MODEL **22/25**

#### TECHNICAL UPDATING

**Models 22 R, 24 R, 25 R to 1987,24 H**

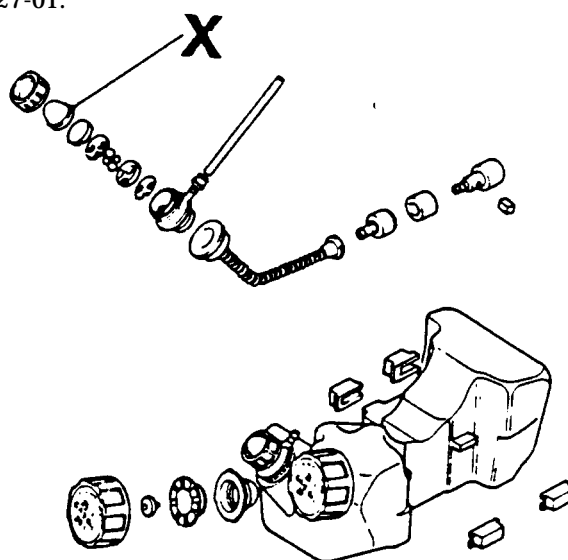
It has been requested from the field that the rubber to the primer (x in the illustration) should be introduced as a spare part.

We now have this part available. Ref. No. 502 19 27-01.
